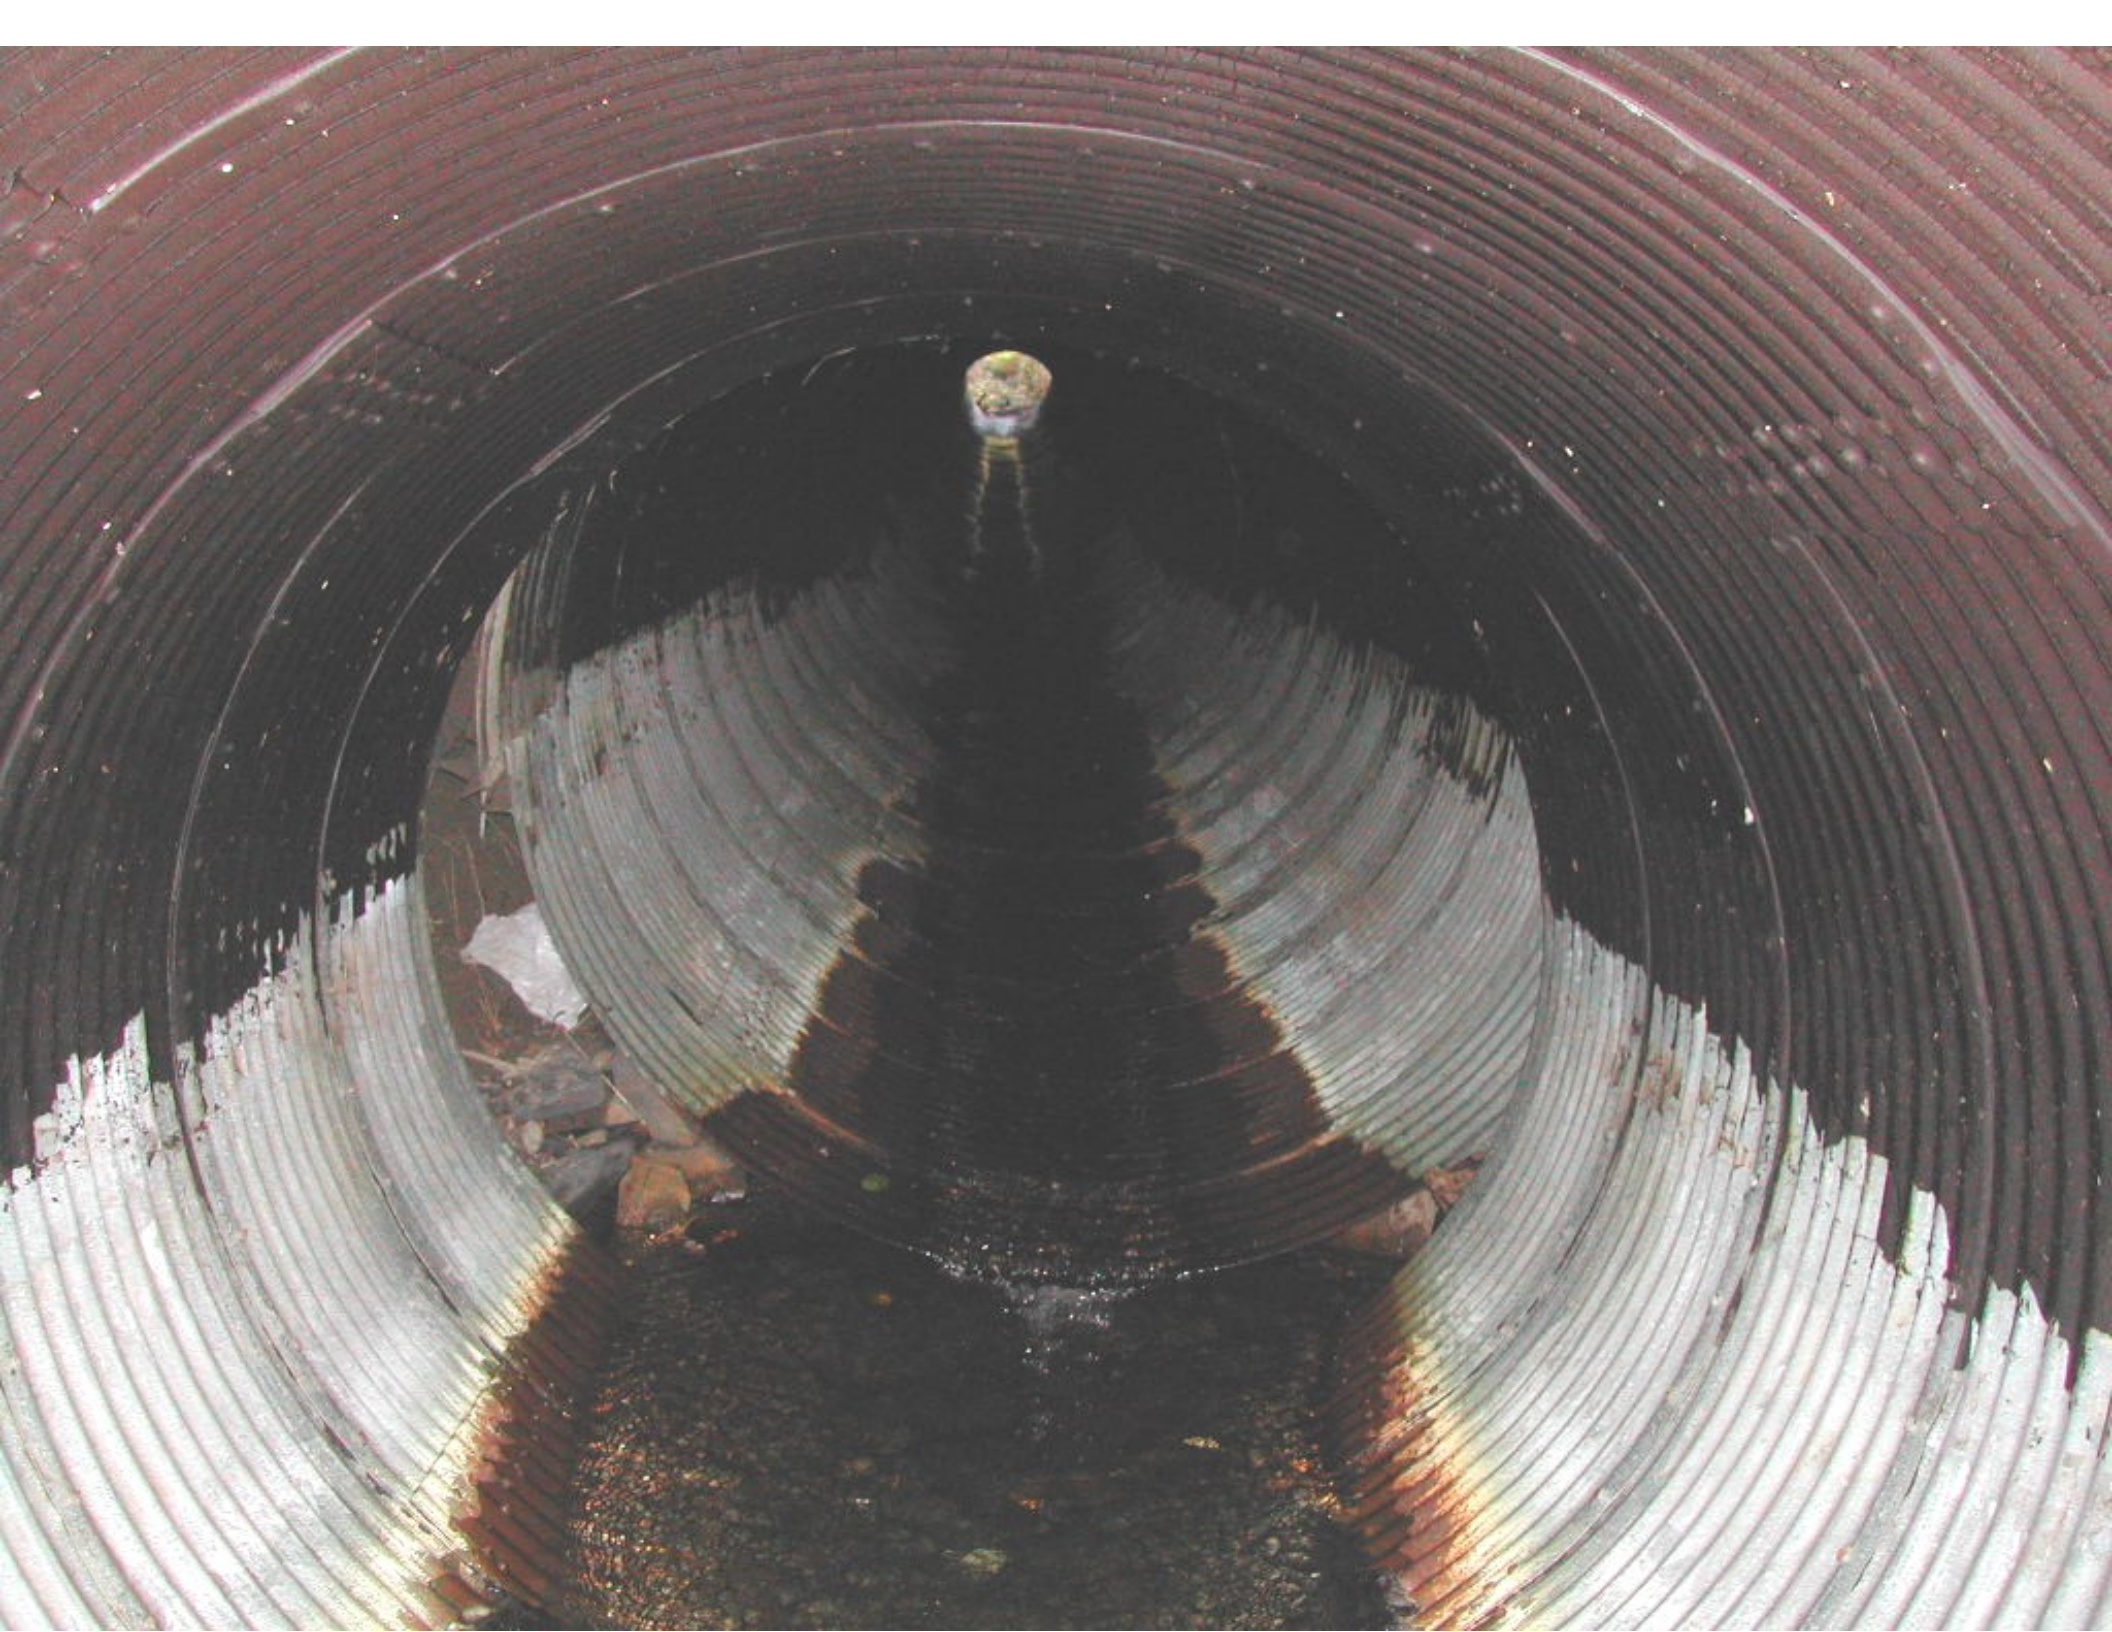
Craddle headwall at outlet should be plumbed and anchored.

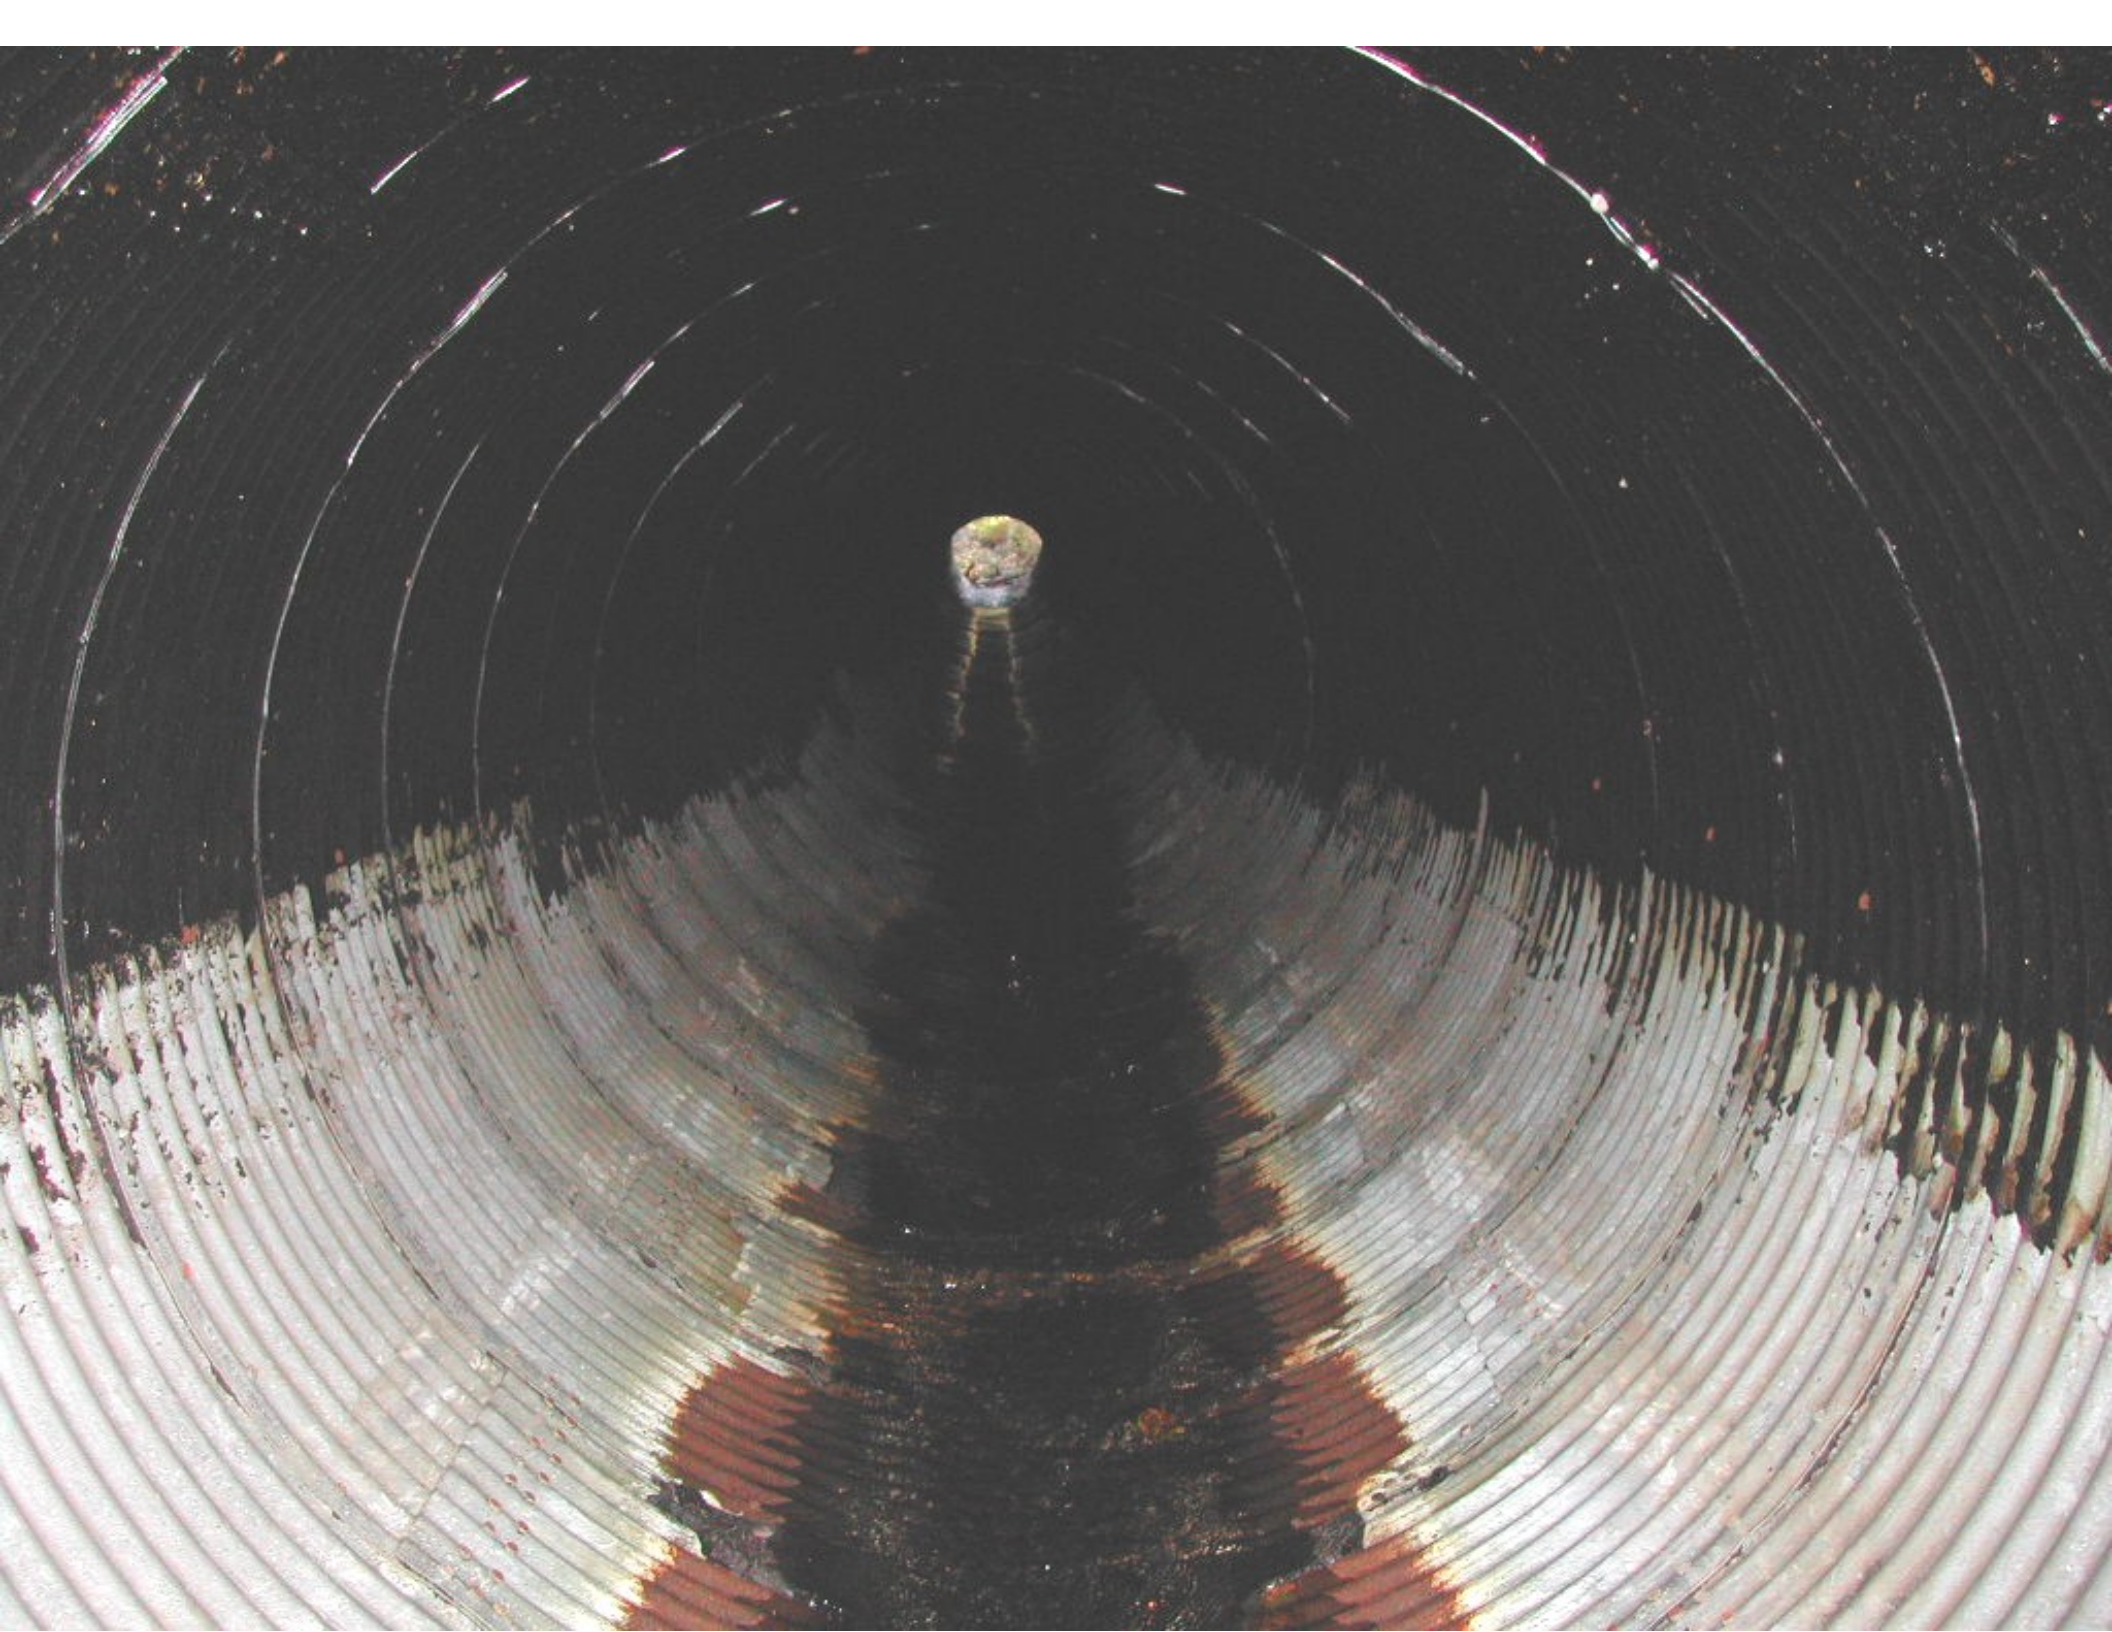
Bank erosion should be repaired.

Culvert at inlet end needs to be repaired
and a collar installed.

Culvert at outlet needs to be reset and a collar installed
